CITY PLANNING COMMISSION

October 27, 2010 / Calendar No. 16

C 100296(A) ZSM
M 920358(D) ZSM

IN THE MATTER OF an application submitted by CRP/Extell Parcel L, LP and CRP/Extell Parcel N, LP pursuant to Sections 197-c and 201 of the New York City Charter, in accordance with Section 2-06 (c) (1) of the Uniform Land Use Review Procedure Rules, for the grant of a special permit* pursuant to Section 74-743 of the Zoning Resolution to allow:

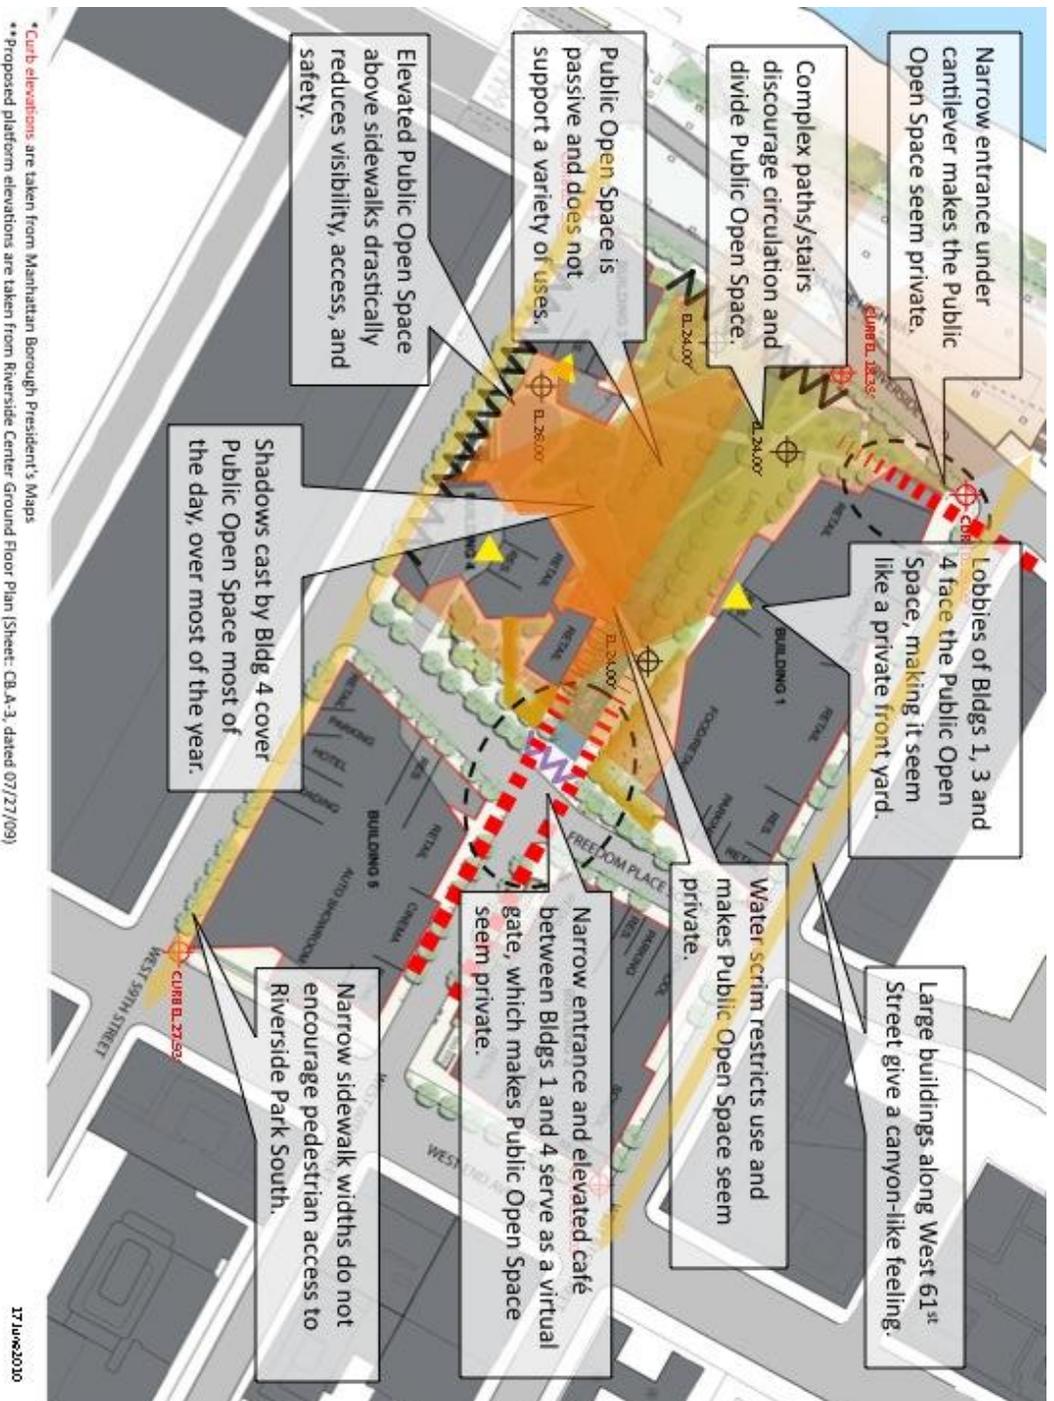
MCB7 recommends “straightening” Freedom Place South to expand the Public Open Space, reinforce the city grid, and provide visual perspectives of the historic powerhouse.

MCB7 recommends modifying the footprint of Building 5 to accommodate the “straightening” of Freedom Place South to expand Public Open Space, further reduce density, reinforce the city grid, and provide visual perspectives of the historic powerhouse.

MCB7 recommends eliminating the private driveway that serves Building 3 to expand Public Open Space and reinforce the city grid.

MCB7 Recommended Modifications

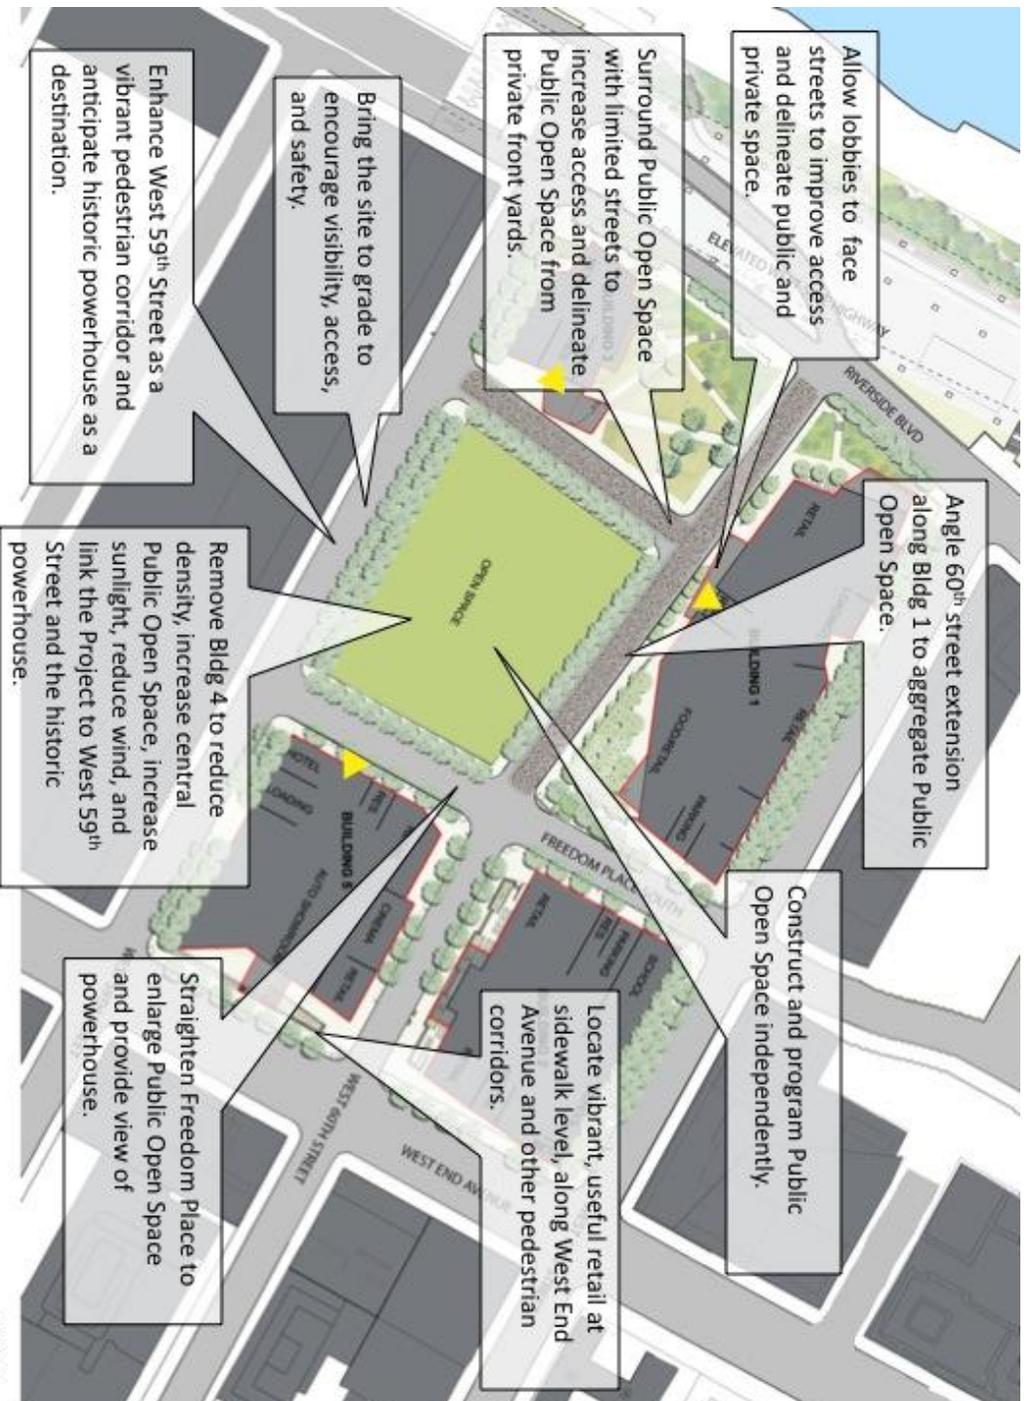
MCB7 Critique of Proposed Site Plan
